Re: McDonald's Restaurant #7027 (Renovation)
520 Government Street, Dryden, Ontario

Re: Revision to SPA Drawings

1 EXISTING SITE PLAN - DEMO SITE PLAN
SCALE: 1/16" = 1'-0"

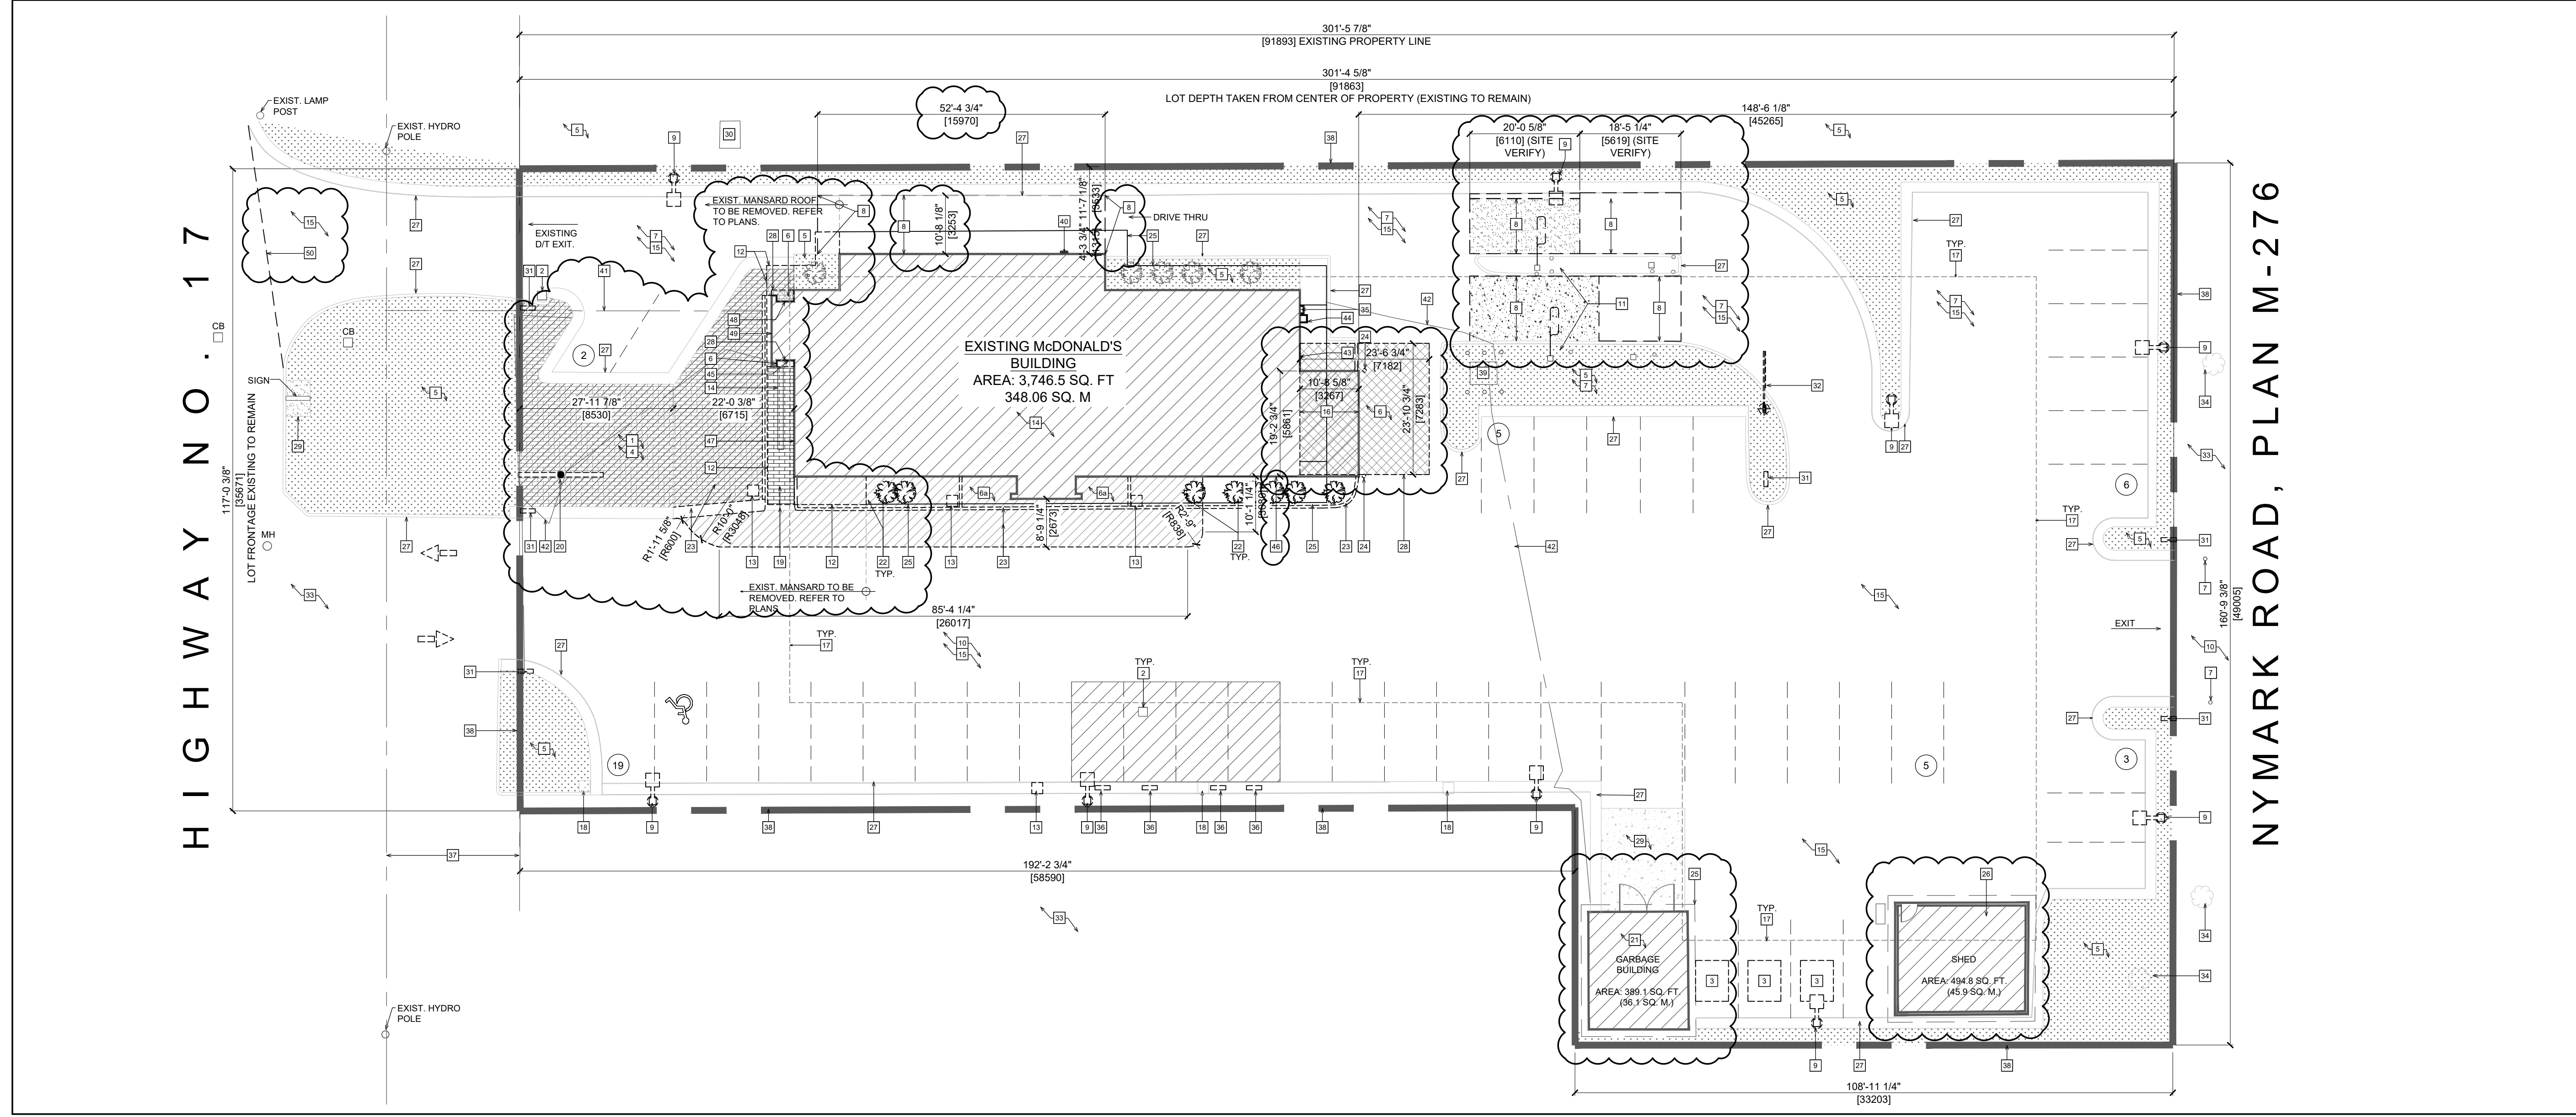
Item 1 Revision: Area of building expansion has been reduced. Refer to Demolition Site Plan Note #6 and Proposed Site Plan Note #28, and Exterior Elevations as shown. New External Cooler/Freezer Walk-In Boxes remain in scope, with slight revisions to their proposed size, as shown on Demolition Site Plan AS1.0 and Proposed Site Plan AS1.1 and Exterior Elevations. Proposed building area revised as shown. Refer to Demolition Site Plan AS1.0 'Project Profile Data' for additional information.

Item 4 Revision: Scope associated with existing mansard roof reduced. Refer to Demolition Site Plan Note #12 and Note #25, and refer to Exterior Elevations as shown, for extent of work proposed.

Item 1 Revision: Extent of new concrete Drive Thru pad and detector loop (to replace existing), updated as shown. Refer to Demolition Site Plan, Note #8 and Proposed Site Plan Note #.14 & Note #1, as shown.

Item 2 Revision: Existing Garbage Building and Existing Storage Shed to remain and be repainted. Refer to Demolition Site Plan AS1.0 Note #21 and Note #26, and to Proposed Site Plan AS1.1, Note #7, as shown.

Item 4 Revision: New Patio/Sidewalk proposed finish updated; to be new interlocking brick pavers to match existing complete with new concrete curb to match existing. Site Plans revised accordingly. Refer to Demolition Site Plan Note #1 and Proposed Site Plan Notes # 57-58, for extent of work, as shown.

Item 6 Revision: Existing Pylon Sign- signage pole and foundations to remain. Existing face to be temporarily removed. Arched lens to be cleaned, relamp with led if required, Canadian flag to be added on arch. Refer to Demolition Site Plan AS1.0, Note #20, and Proposed Site Plan, Note #22, as shown.

Item 8 Revision: Extent of Drive Thru asphalt pavement replacement revised, as shown. Please refer to Demolition Site Plan Note #50, and Proposed Site Plan Note #62.

DRAWING TITLE
PROPOSED SITE PLAN

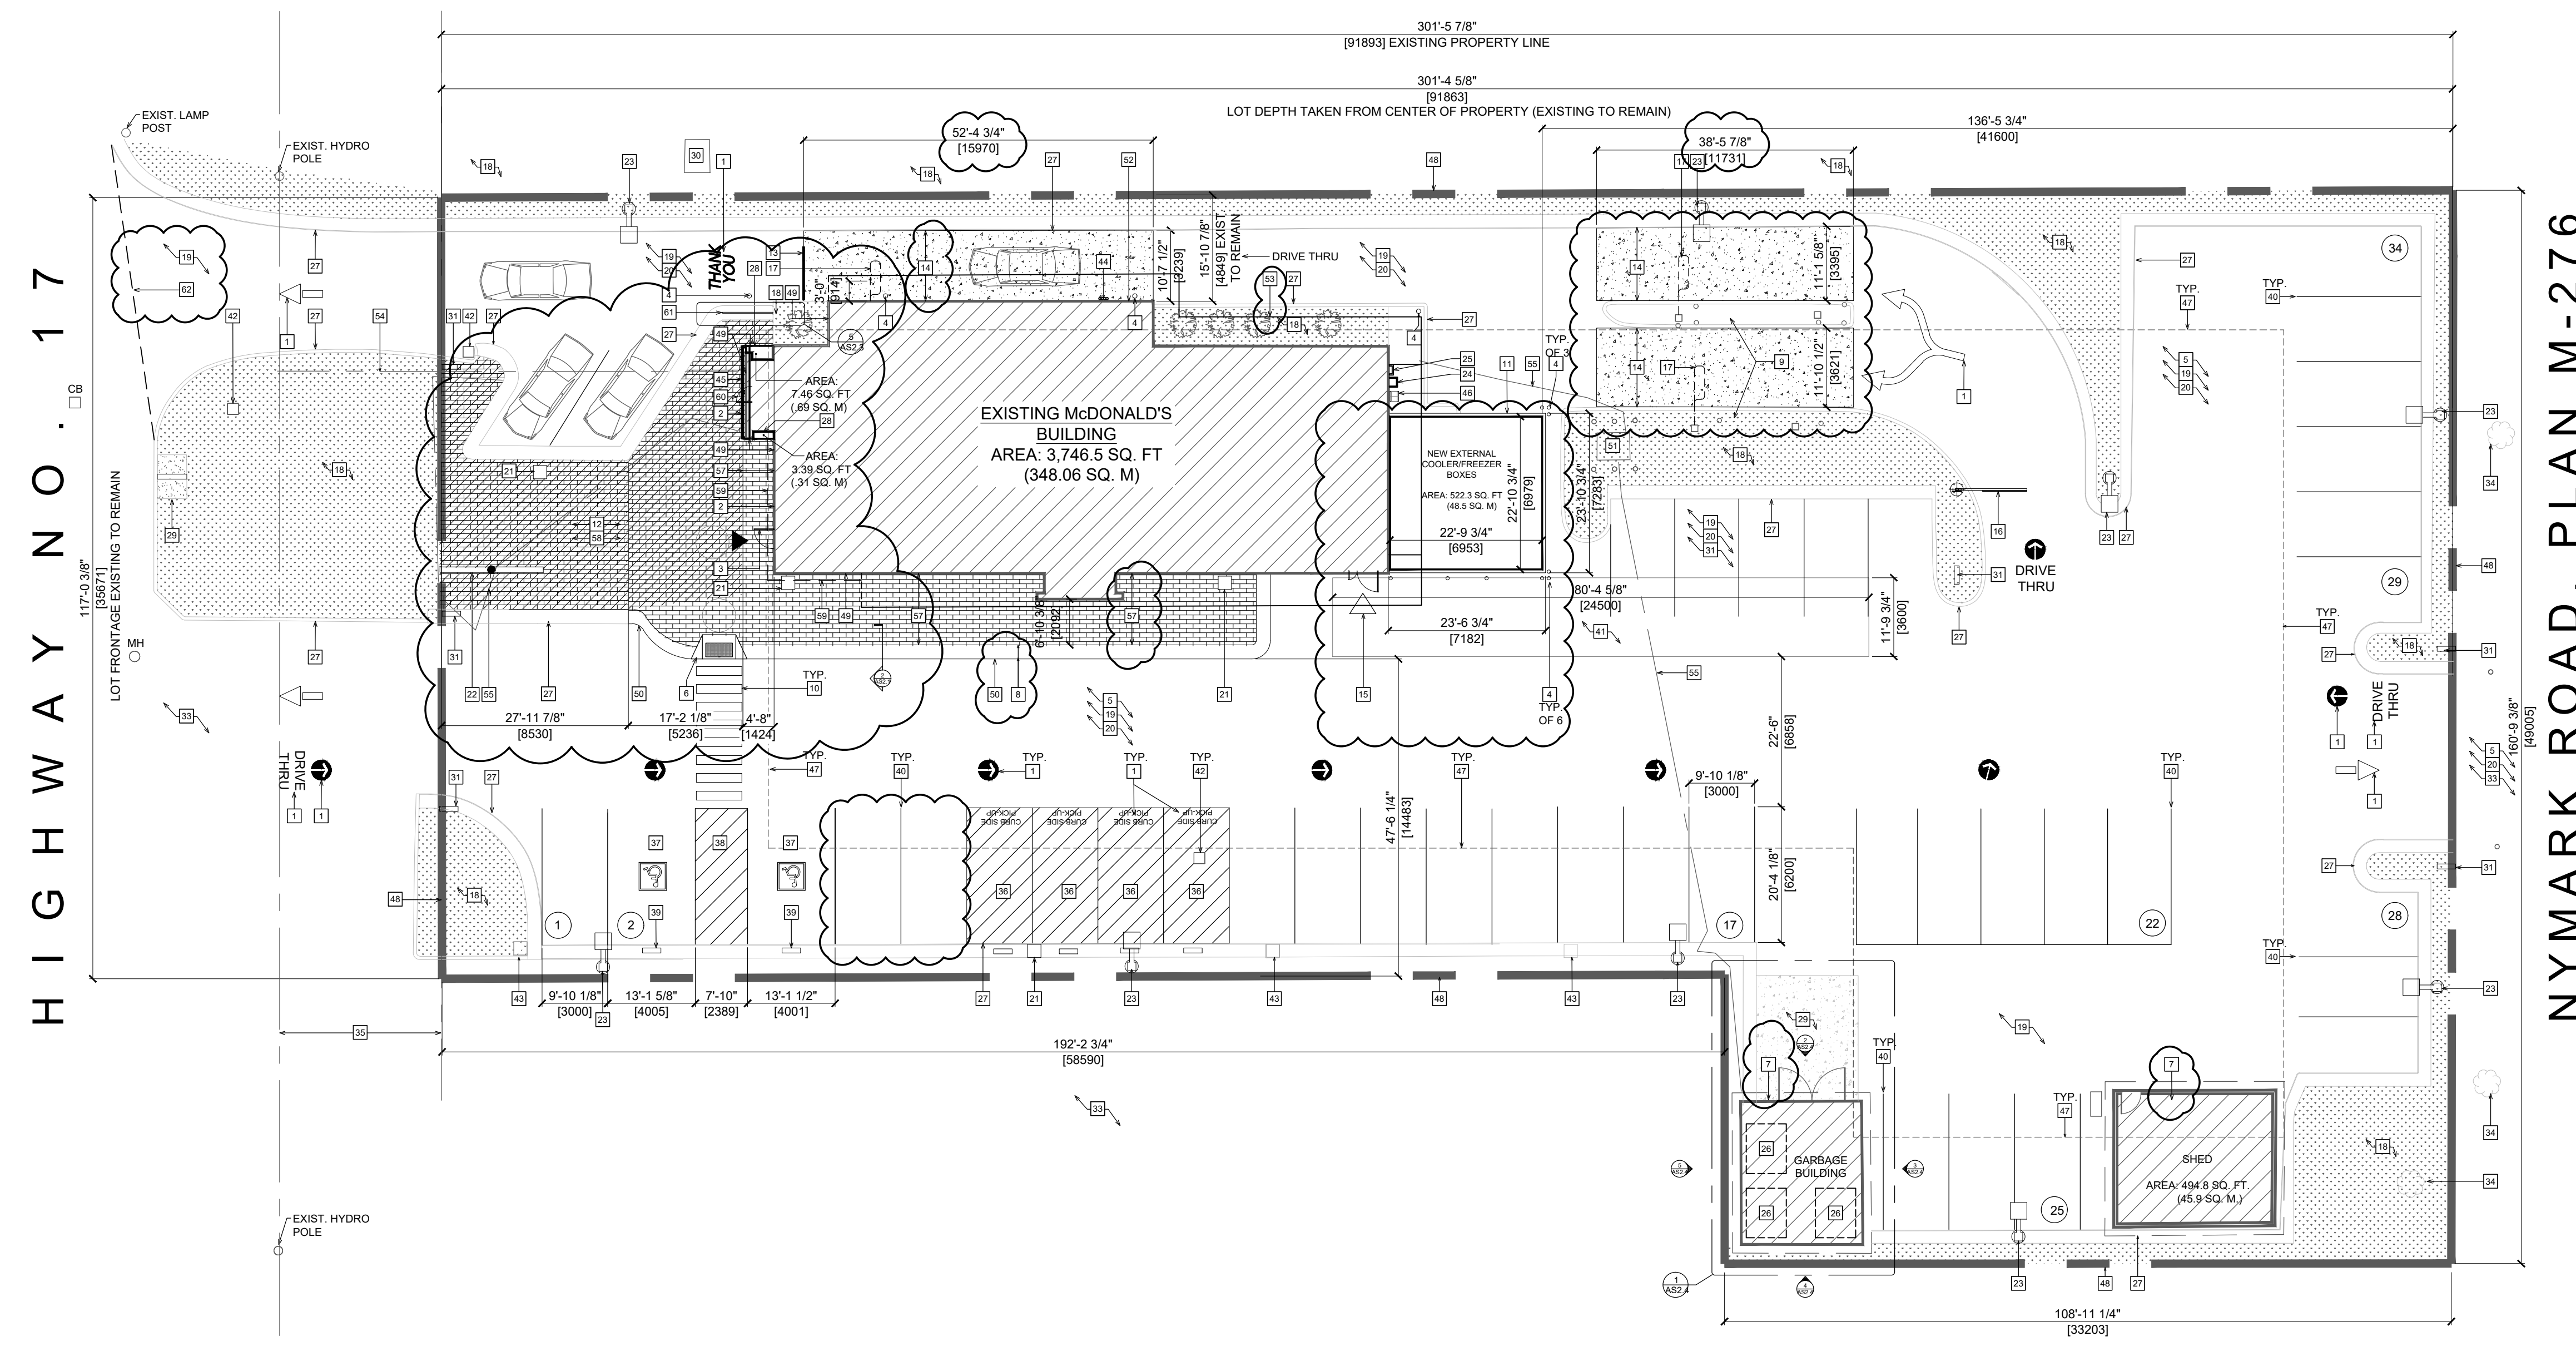
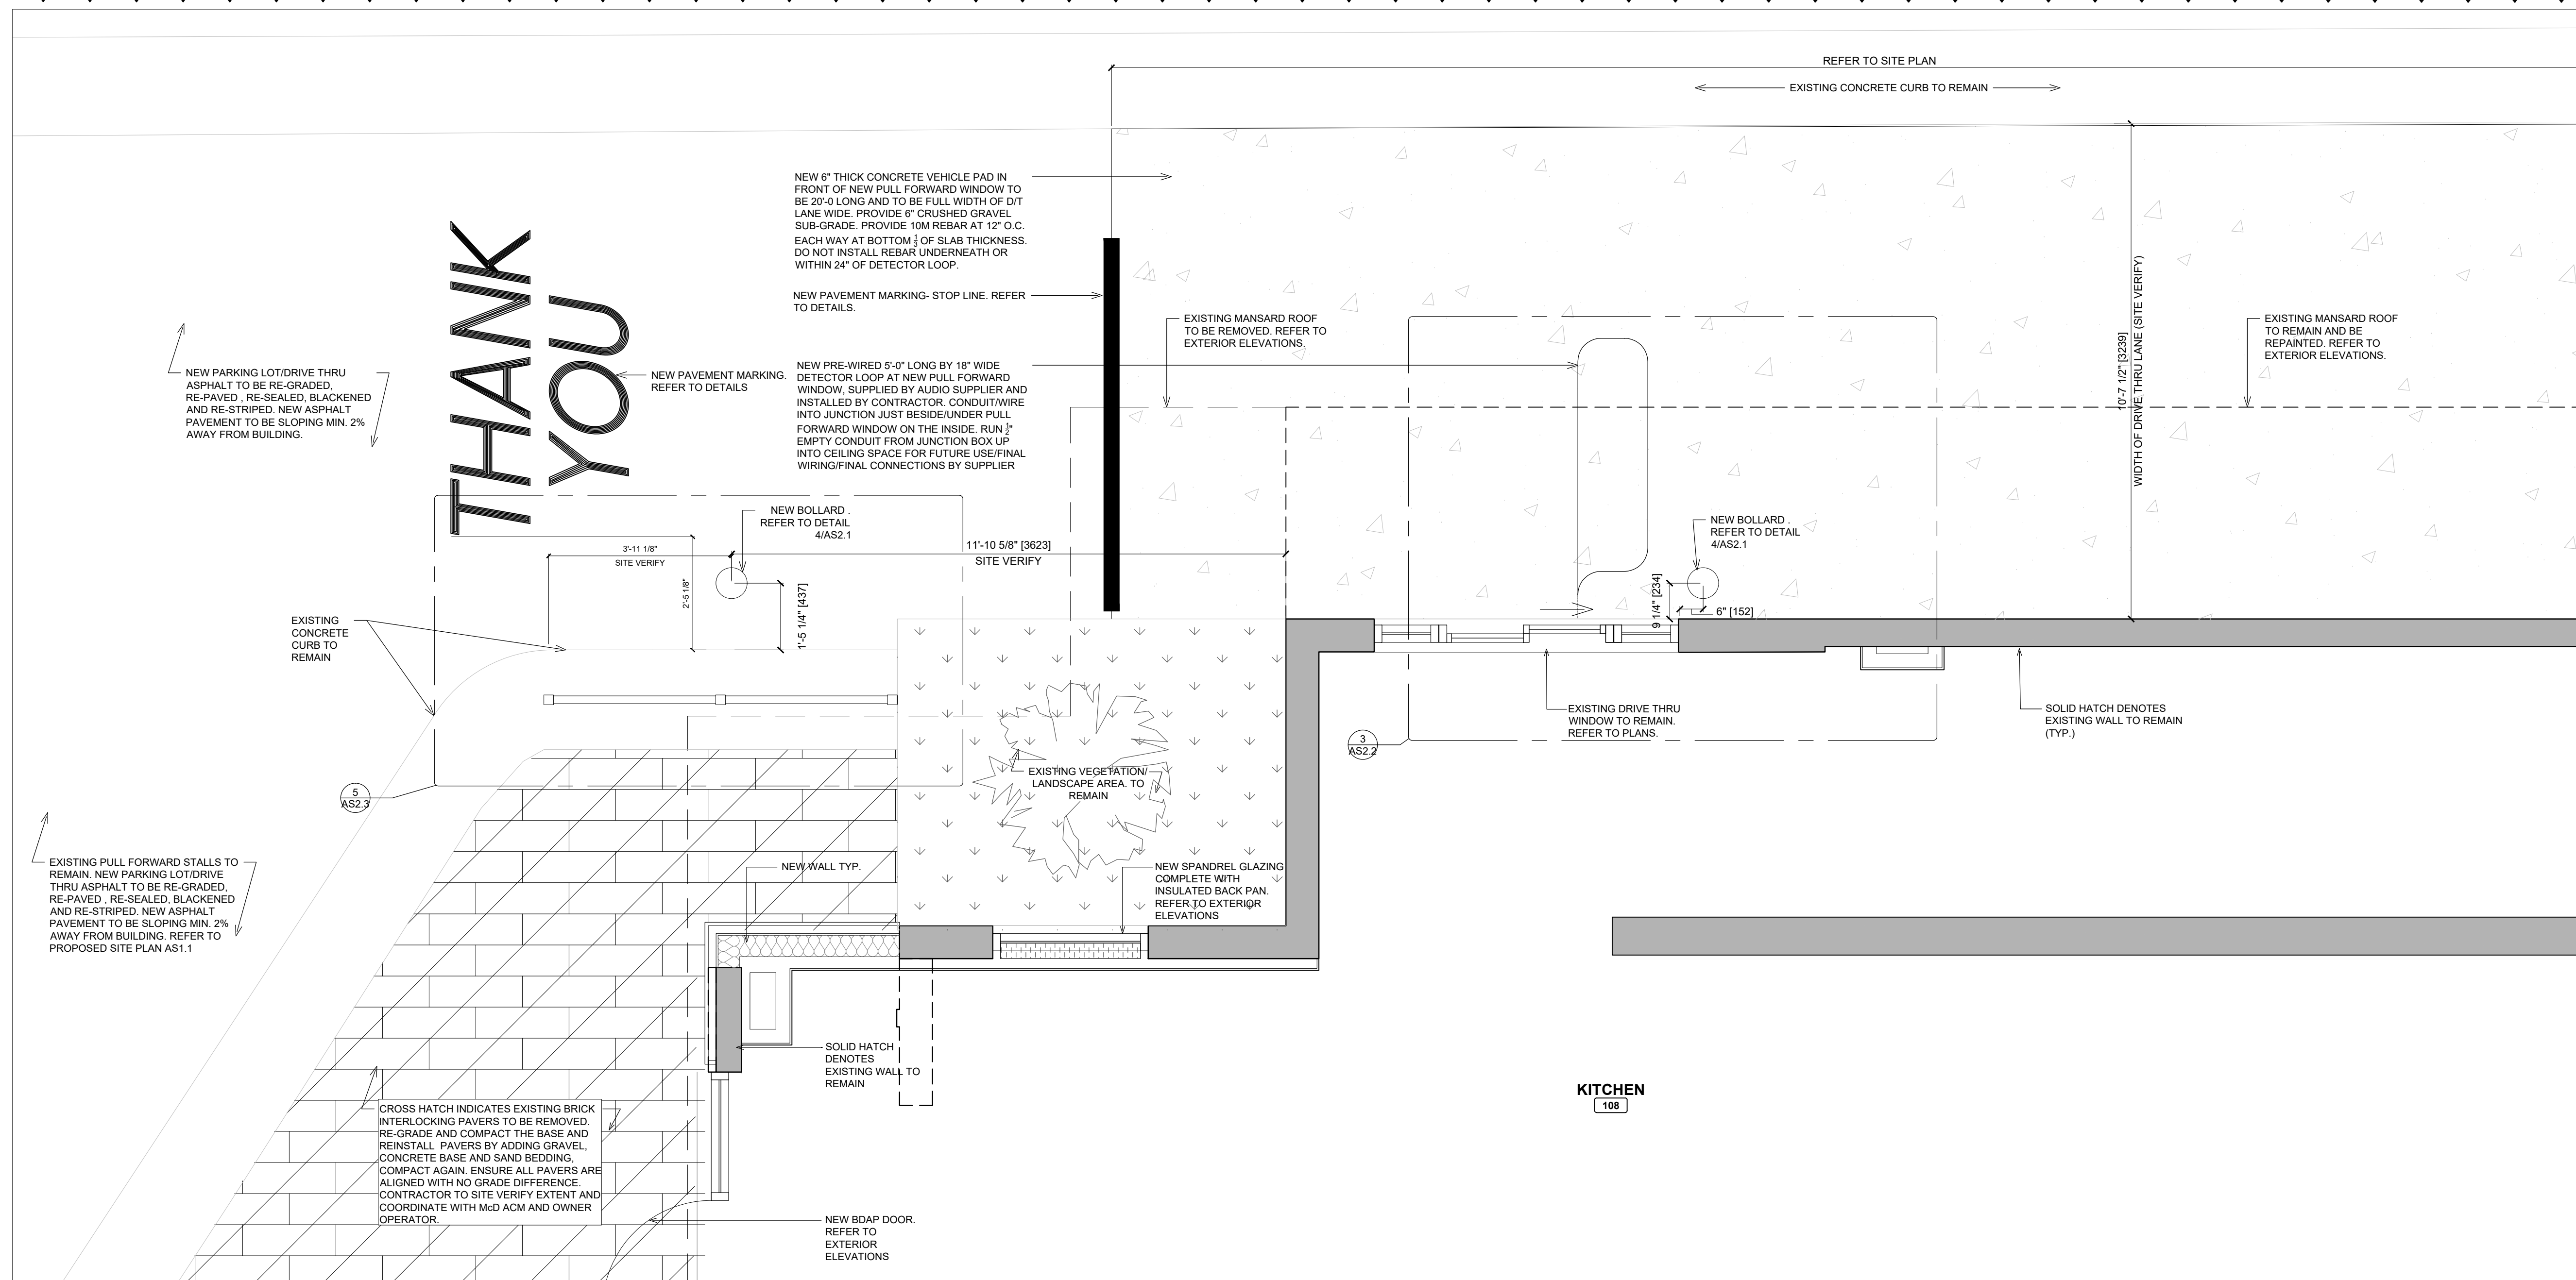
Item 2 Revision: Location and orientation of new proposed blade tower, complete with new signage and led lighting, revised on front elevation, and to be perpendicular to building. Refer to new Proposed Site Plan Note #45, and to revised Exterior Elevations 1/A5.0 and 2/A5.0, as shown.

Item 7 Revision: New guardrail proposed at existing Drive Thru for increased pedestrian safety at drive thru and employee safety at existing pull forward parking locations off kitchen BDAP. Refer to Note #61 on AS1.1 Proposed Site Plan and to Site Details.
